Groundwater Transfer Review Summary Form

Application: T-14334

Ground Water Review Form:			
irces Department E, Suite A	☑ Water Right Transfer☐ Permit Amendment		
-1271			
	cation		
	\square Other		
	Applicant Na	me: Tooley Water District	
\boxtimes APOA	\square SW \rightarrow GW	\square RA	
\square POU	\square OTHER		
	Ι	Date of Review: <u>8/13/2025</u>	
Date Reviewed by GW Mgr. and Returned to WRSD: <u>JTI 8/</u> 15/25			
oplication is insufficient to evaluate whether the proposed

Well Location Map

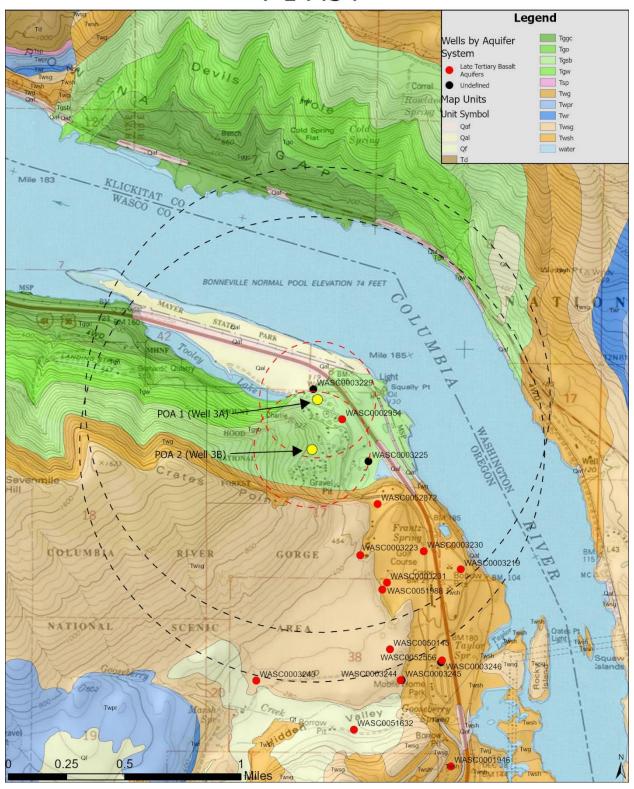
1. Basic description of the changes proposed in this transfer: The applicant requests "Well 3" be added to Certificate 38186 at the full authorized rate (0.06 cfs). Two potential locations ("3A" and "3B") are included in the application, but only one will be developed.

2. Will the proposed POA develop the same aquifer (source) as the existing authorized POA? Comments: Columbia River Basalt Group (CRBG) flows consist of a permeable flow top, a dense impermeable flow interior, and a flow bottom of variable thickness (Reidel et al., 2002). Different flows within the CRBG are often hydraulically isolated, with the dense flow interior separating water bearing interflow zones. Well 2 (WASC 2954) likely develops water-bearing zones (WBZs) in the upper members of the N2 magnetostratigraphic unit of the Grande Ronde Basalt formation of the CRBG (Sentinel Bluffs, Winter Water, and possibly Ortley members) (Anderson, unpublished). Well 3A and Well 3B will also develop the Late Tertiary Basalt Aquifer system, though they will be completed ~ 400 to ~500 feet deeper than Well 2. As a result, the proposed wells will likely develop aquifer(s) from deeper members within the R2 or N1 units of Grande Ronde Basalt (Anderson, unpublished; Korosec, 1987). Due to the nature of CRBG emplacement, it is unlikely that deeper flows penetrated by the proposed wells are hydraulically connected to the flows found in shallower Members of the Grande Ronde Basalt that are developed by Well 2.

Well 1 (WASC 3229) does not penetrate basalt and develops the Late-Quaternary Tertiary Sedimentary Aquifer system.

Therefore, Well 3A and Well 3B will not develop the same source as the existing authorized

- 8. What conditions or other changes in the application are necessary to address any potential issues identified above: The proposed well must be completed to a similar elevation amsl—or otherwise demonstrated to be completed in the same aquifer—as Well 2 in order to be added as an APOA to the "basalt portion" (0.04 cfs, Well 2) of Certificate 38186. Well 1 does not develop the Columbia River Basalt Aquifer system, so the rate of 0.02 cfs cannot be transferred to a new basalt well.
- 9. Any additional comments:_____
